EMBDEN REARING STATION PIPELINE REPLACEMENT

Addendum #2

BGS Project No: 3289

**TYPICAL HDPE PIPE TRENCH
BEDDING DETAILS**

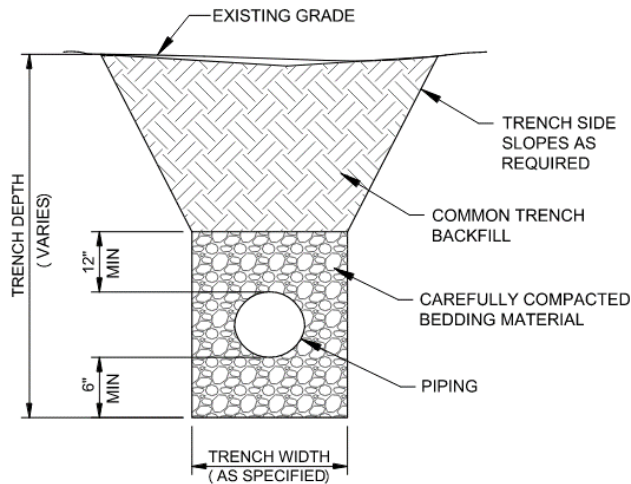
1. Please clarify pipe bedding specifications.
 - a. See Detail Below

Bedding Material- Class 1B Well-graded crushed stone
